**Second
Five-year Review Report**

**Valley Park TCE Site
Valley Park
St. Louis County, Missouri**

September 2008

**Region 7
United States Environmental Protection Agency
Kansas City, Kansas**

FIGURE 5. CONTAMINANT CONCENTRATION TRENDS IN WOU EXTRACTION WELL

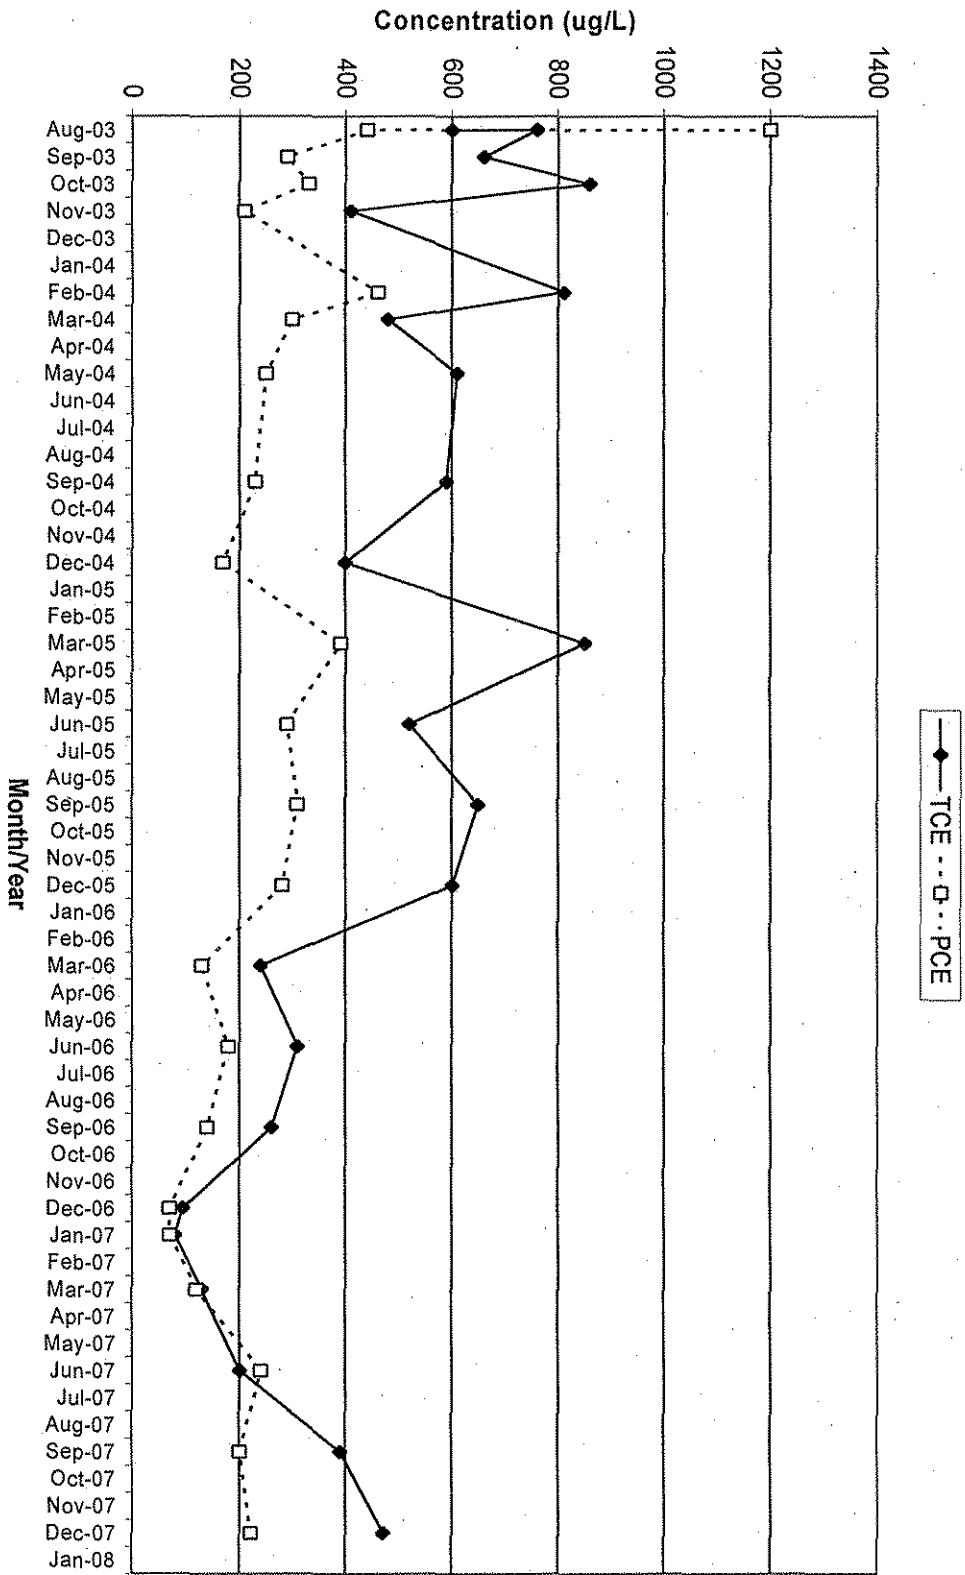
On the basis of quarterly results, Figure 5 was developed depicting the trend in influent groundwater concentration with time. The trend indicates that the influent concentration has decreased since December 2003 but exhibits a very noticeable upward trend beginning in early 2007. Before early 2007, VOC concentration levels suddenly decreased during 2006. The reason for the decrease is being investigated. One possible cause is the reduction in well capacity in the extraction well. The work conducted on the well in late 2006 and early 2007 may have improved the local hydraulic control which resulted in concentrations returning to pre-2006 levels.

- Figure 5 presents contaminant concentration trends in the extraction well for the last five years of sampling results. Overall, contaminant concentrations for the primary chemicals of concern have shown some variability but have been on a general downward trend. Total VOCs (the sum of all primary chemicals monitored) decreased from a high of 2,130 micrograms per liter ($\mu\text{g/L}$) in August 2003 to a low of 179 $\mu\text{g/L}$ in December 2006. Beginning in December 2006, total VOC concentrations have increased with a December 2007 level of 732 $\mu\text{g/L}$. As discussed previously, the Department suspects that the reduced pumping rate in the extraction well, fluctuations in groundwater levels, and a possible remaining soil source of contamination are responsible for these contaminant trends.

WOU – Restore pumping rate in extraction well. Potential solutions include but are not limited to well redevelopment using chemical and/or physical cleaning of the screen or installation of a new well.

Figure 6. WOU Monitoring Well Locations
(Figure produced from design computer model; not actual water elevations presented)

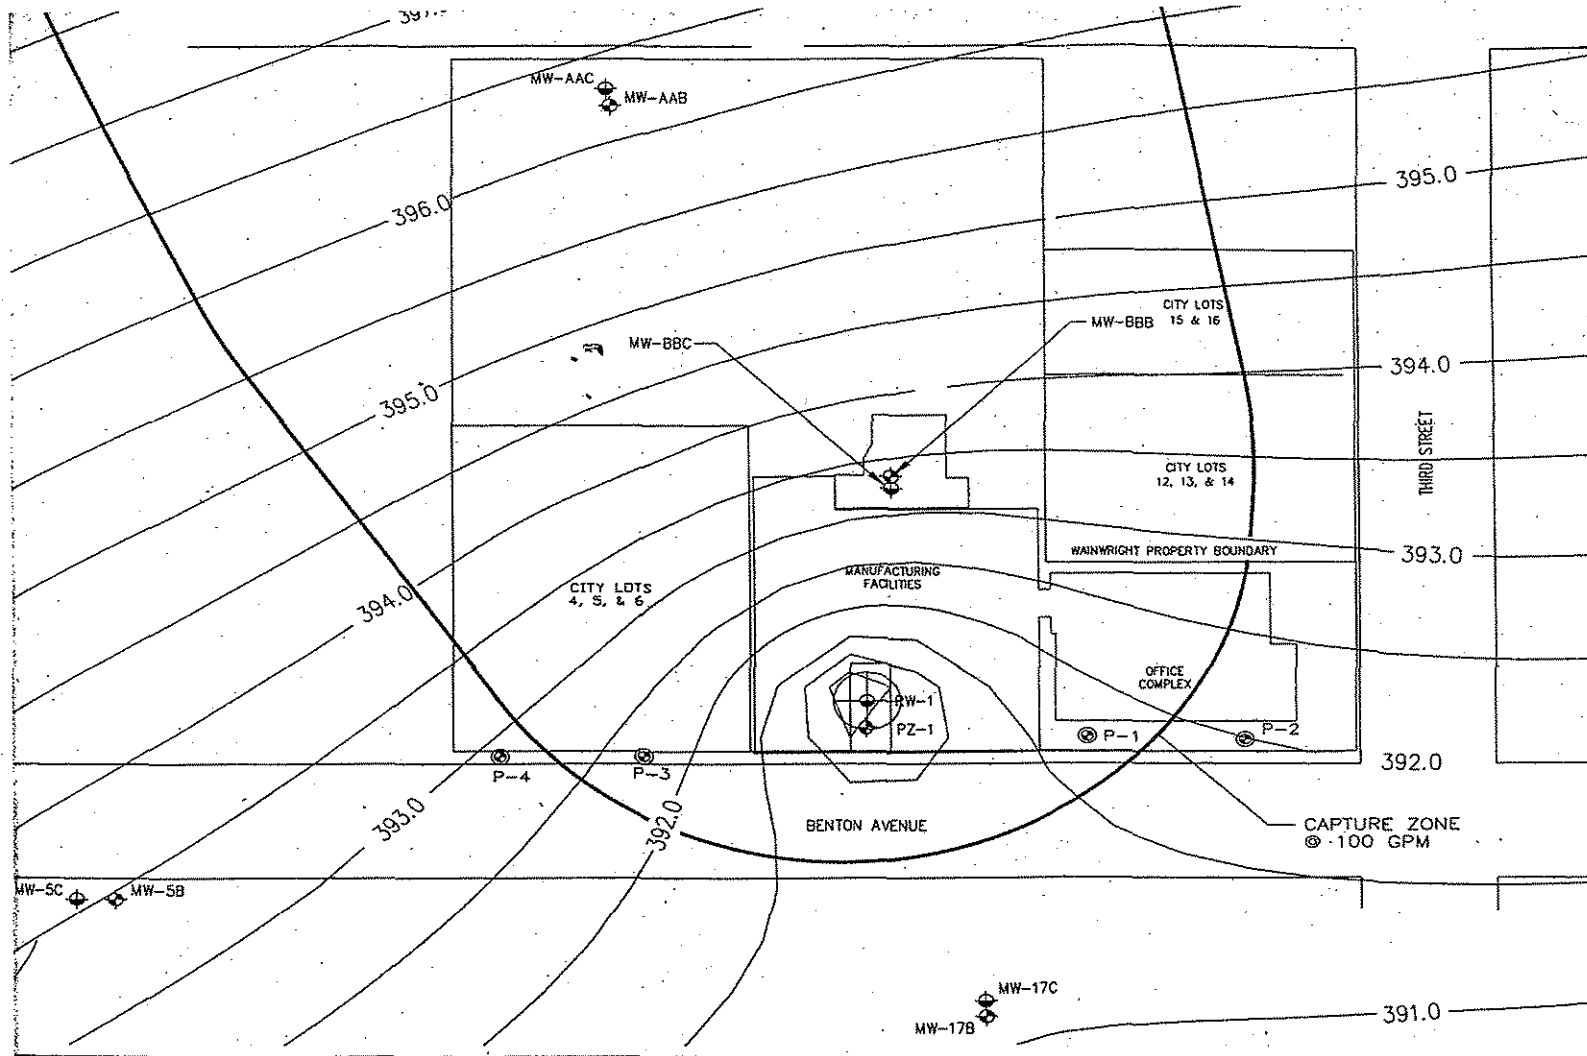
The Department is concerned that a reduction in the GETS extraction well pumping rate has impaired the effectiveness of the hydraulic control of the groundwater beneath WOU. Effectiveness is assessed by evaluating water levels and groundwater quality. In May 2007, concentrations of TCE and PCE detected in monitoring well MW17C, located 225 feet downgradient from the WOU source area, increased to 47.8 ppb PCE and 13.6 ppb TCE from previous nondetection levels in 2006 (refer to Table 4 for a WOU summary of monitoring well results and Figure 6 for well locations). The increased downgradient contaminant levels indicate the potential that hydraulic control has not been maintained. Groundwater quality data from other wells that were monitored over this same period are essentially stable.

FIGURE 9. MAP OF SOIL CONCENTRATIONS BEFORE THE EXCAVATION AT OU2

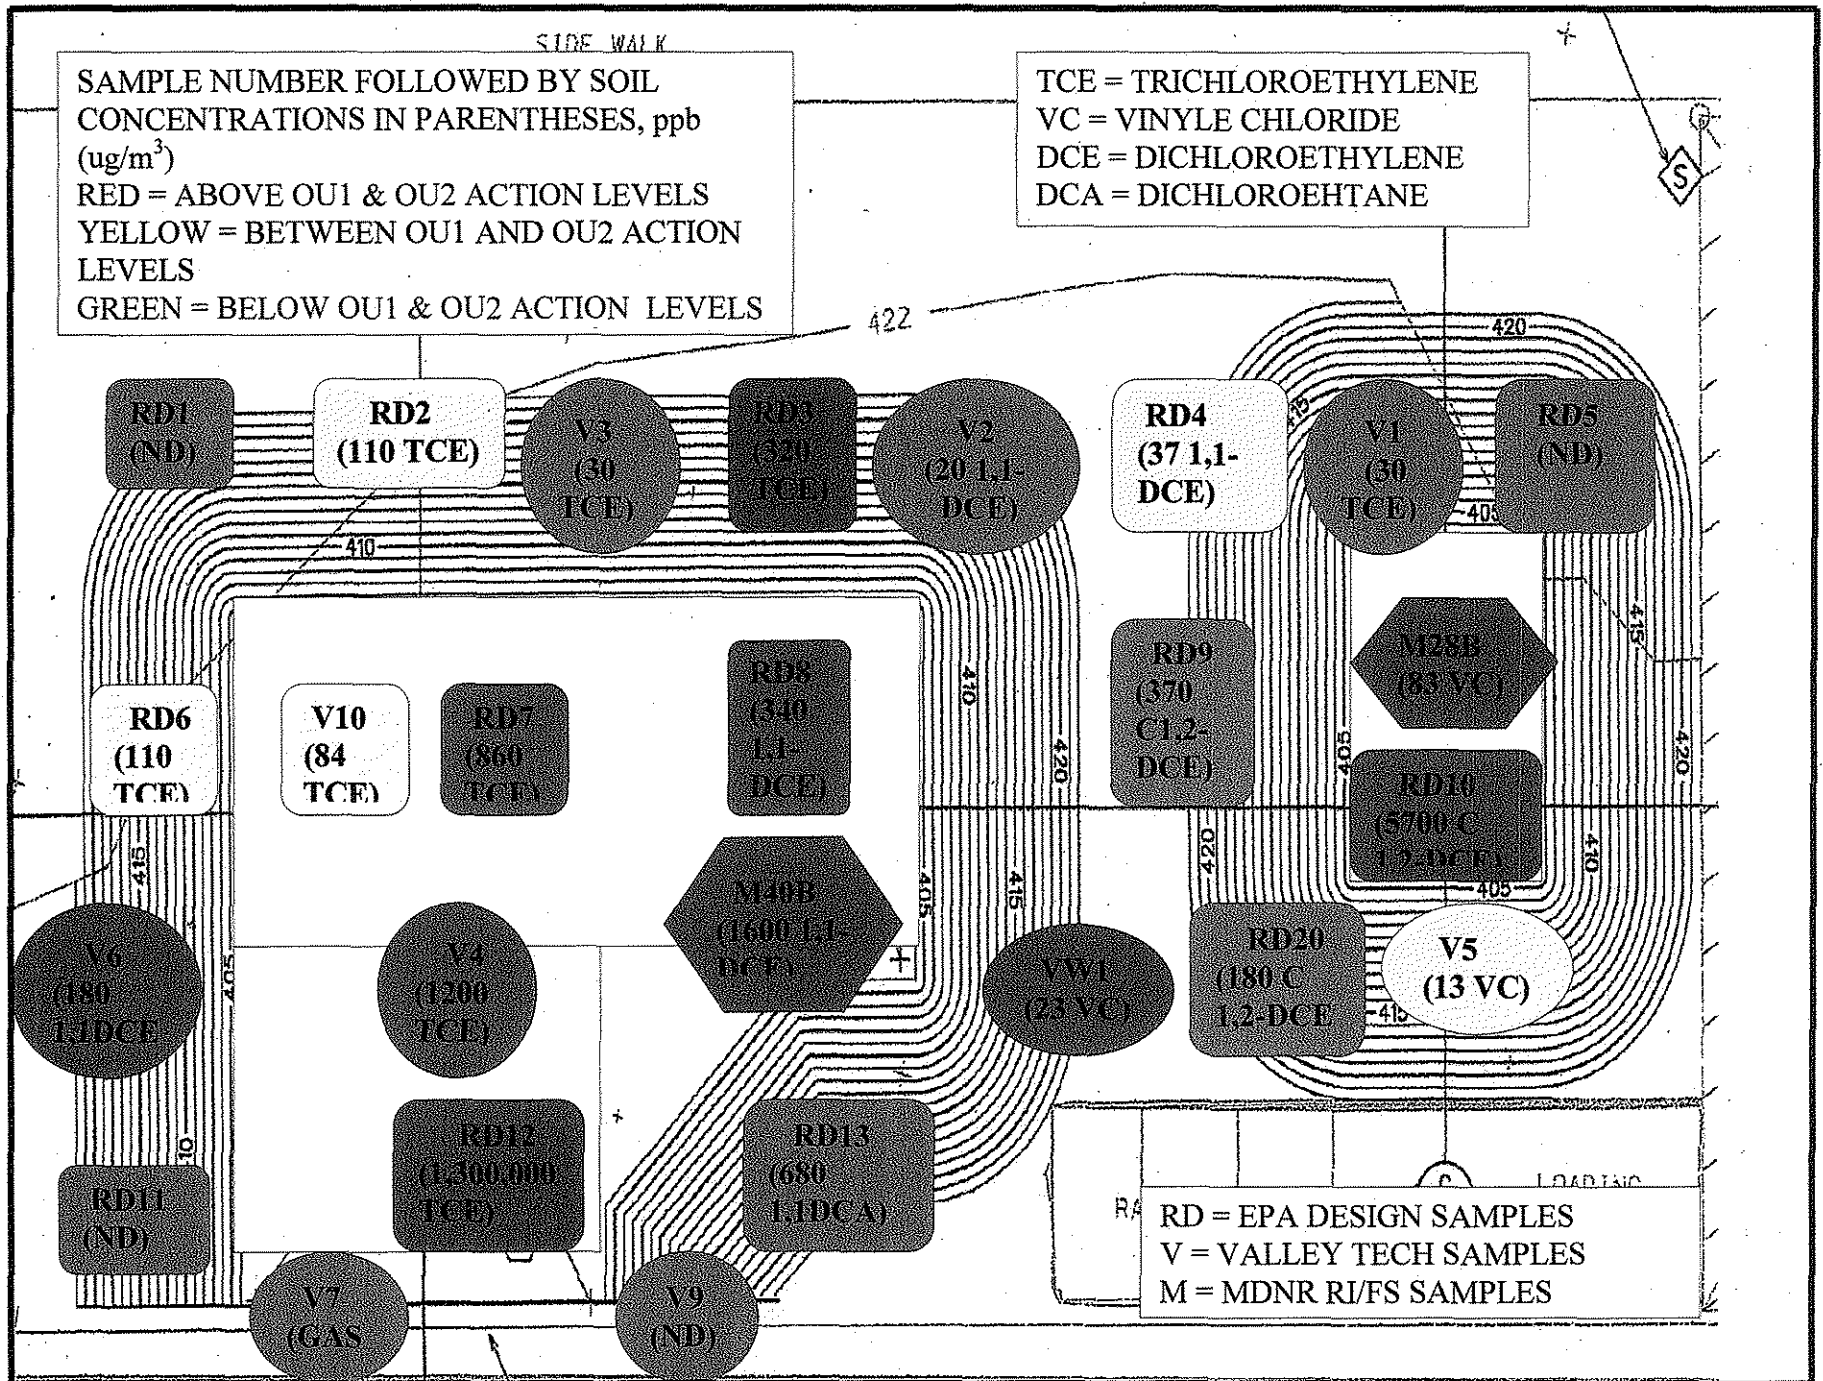
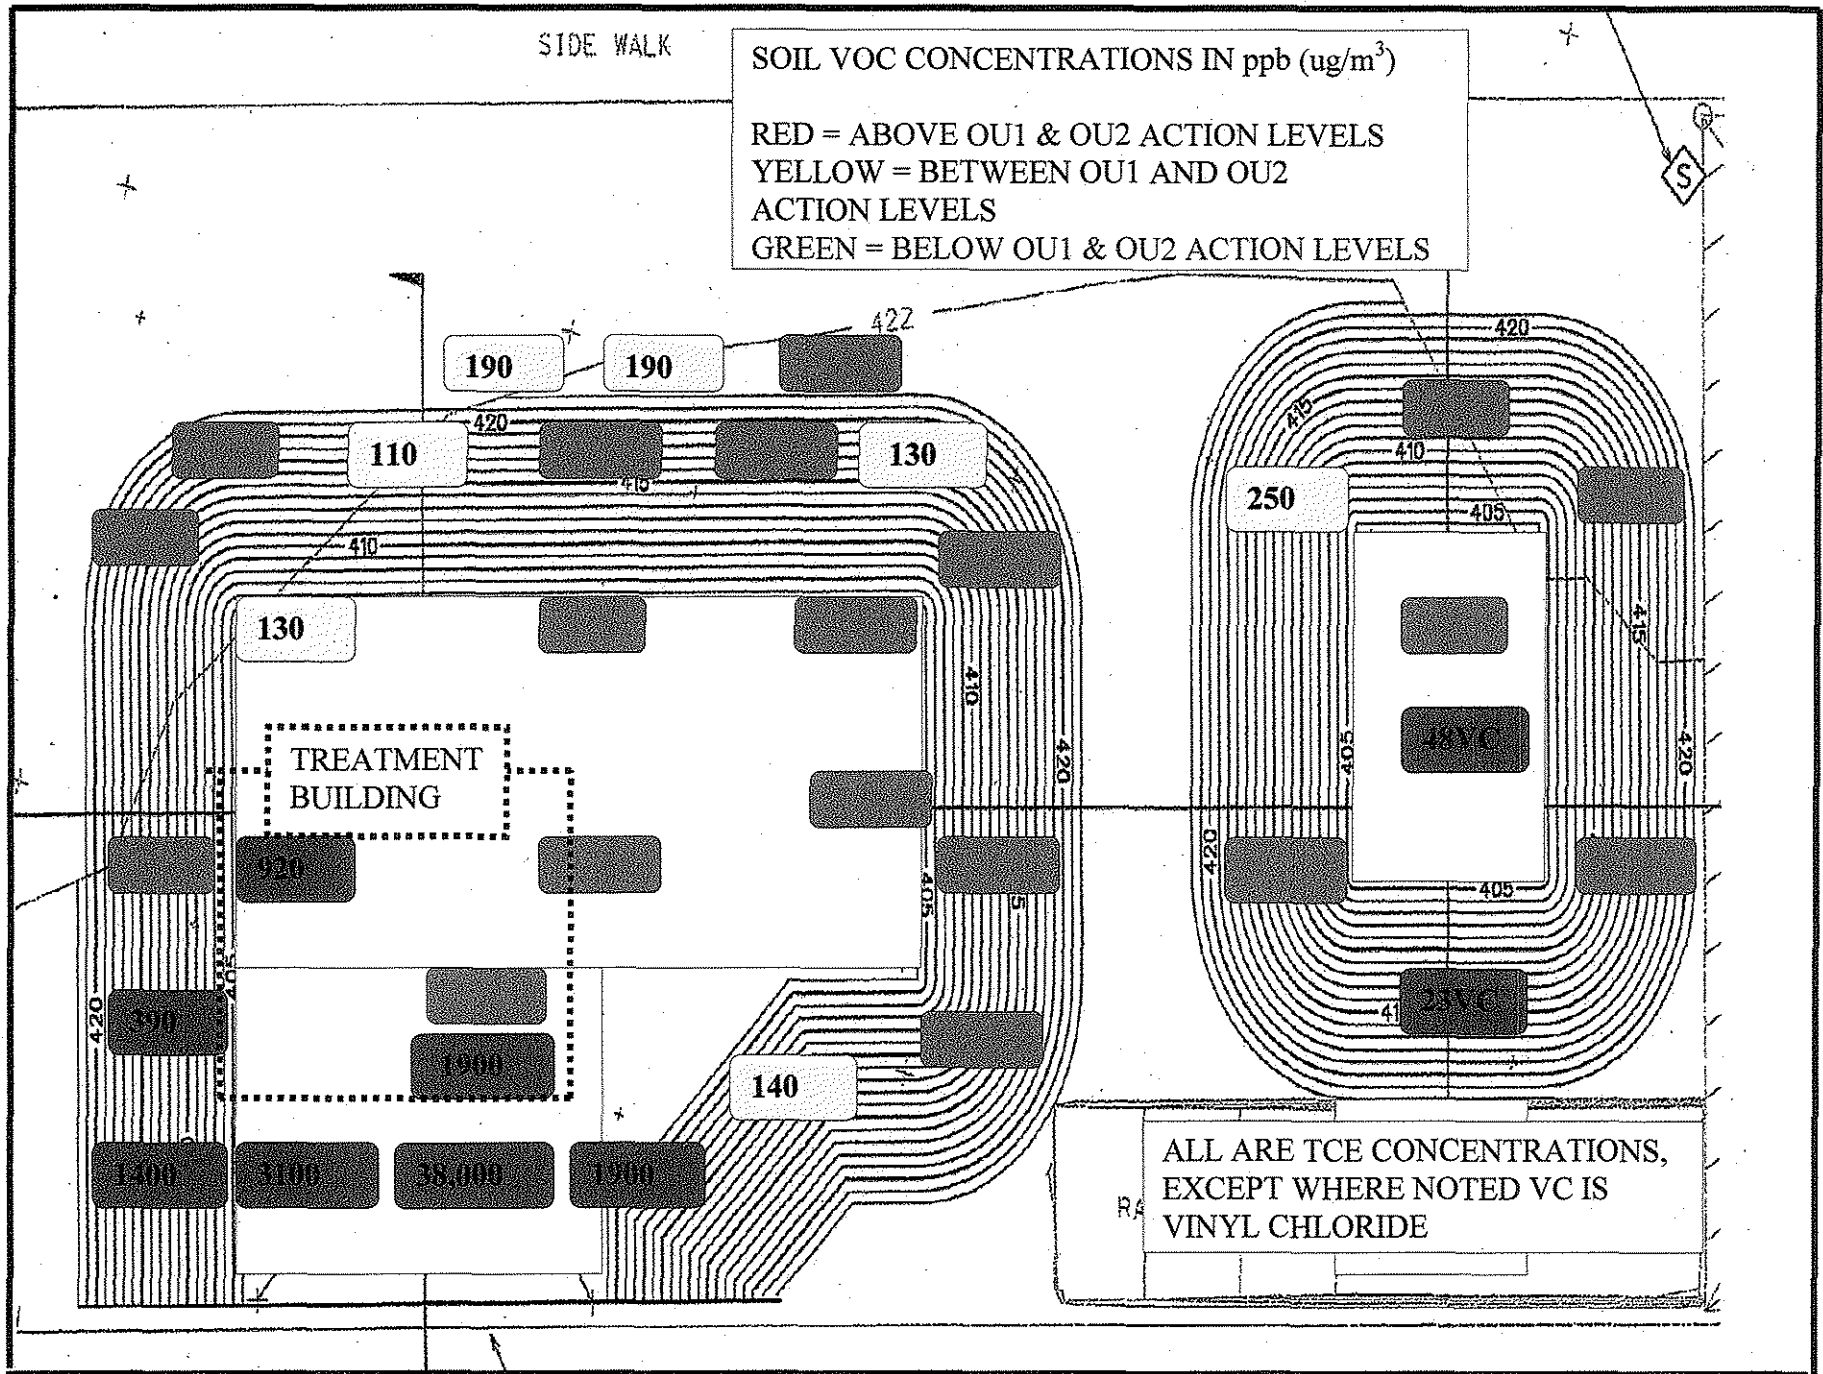
Figures 9 and 10 present the soil sampling results before and after the excavation work, respectively. Comparing the two figures clearly shows that the soil excavation was highly effective. For example, the most contaminated location adjacent to the alley was reduced 97 percent in concentration. Essentially, the condition of the soils following excavation is that (1) widespread, low levels (below 250 ppb VOCs) of contamination exist over a large area of the Valley Technologies' parking lot; and (2) the two release/source areas have been found with the one beside the building effectively removed and the one beside the alley significantly reduced in contaminant mass. Although significantly reduced, the contamination levels in the alley source area are still at high levels (up to 38,000 ppb TCE).

In conclusion, the Agencies find that the soil excavation work was very effective for OU2 soil source areas, but additional work is required in the alley source area to achieve the ten-year remediation goal.

OU2 – Investigate alternative treatment methods to achieve soil performance standards.

FIGURE 11. CONTAMINANT CONCENTRATION TREND IN OFF-GAS VAPOR FOR WOU SOIL VAPOR EXTRACTION SYSTEM

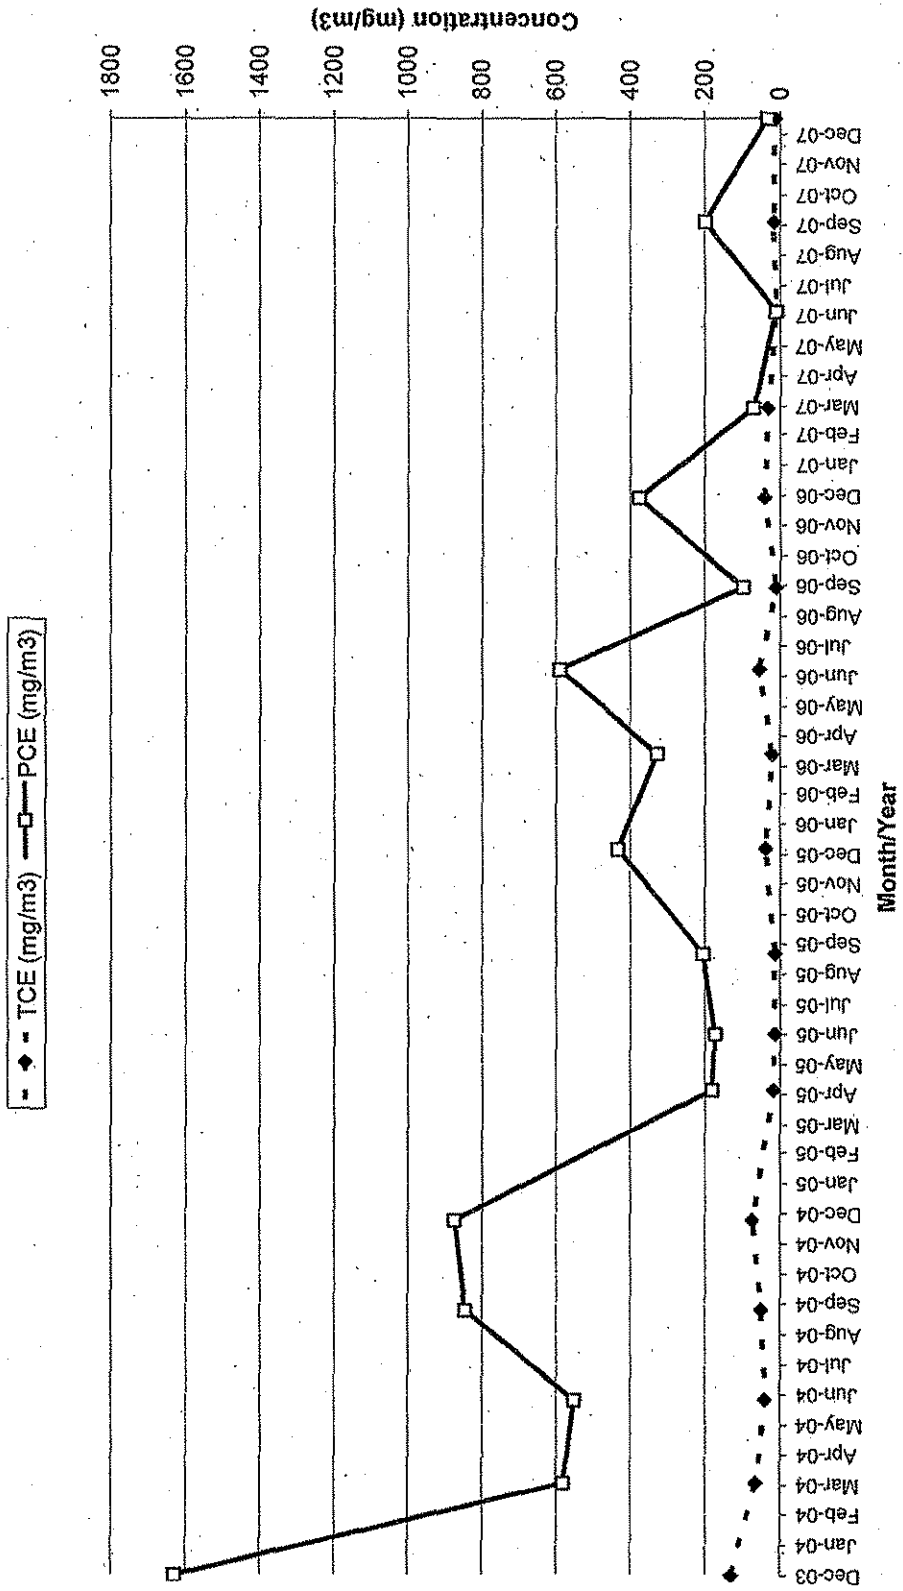
- SVE vacuum pressures have historically operated at lower values than expected due to excess water (moisture) in the vacuum lines/wells.
- PCE and TCE concentrations measured in the SVE influent stream have shown a variable but steadily decreasing trend in the last five years ranging from 1,500 milligrams per meter cubed (mg/m^3) to 19.84 mg/m^3 for PCE and from 130 mg/m^3 to 12.78 mg/m^3 for TCE (see Figure 11).

- A significant quantity of PCE and TCE has been recovered over the last five years, but the rate of removal has decreased to a point where the trend is exhibiting asymptotic behavior. This behavior may be attributed to but not limited to the following factors (and possible combination): (1) low desorption rates of contaminants in soil due to

diffusion-controlled removal of contaminants within low permeability zones, (2) SVE extraction wells that are not properly located or screened to treat all contaminated areas, (3) an insufficient number of SVE wells, and (4) the presence of an unaddressed source of contaminants preventing cleanup using SVE within the remedial goal.

WOU – Perform an assessment of the soil vapor extraction system through additional performance monitoring and possible remaining soil source contamination. If necessary, evaluate alternative treatment options.
